Technical Service Bulletin

TSB Number: 381

Safety Recall Campaign **Re-Programming of KIB Electronics V-Bus Lighting and Control Network**

Fig.3

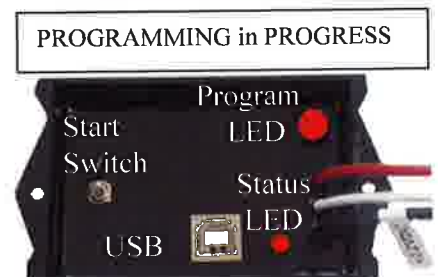
- !!!Do not unplug or shut off power during this step!!!
- !!All lights will turn off randomly during re-programming!!
- Switch plate backlighting may also turn off and on individually
- This step should take around 2-7 minutes
- Press the **START** button
- Programming LED will flash **RED** while programming
- V-Bus Network status LED will flicker **RED** during this time
- Programming LED will light solid **GREEN** when finished
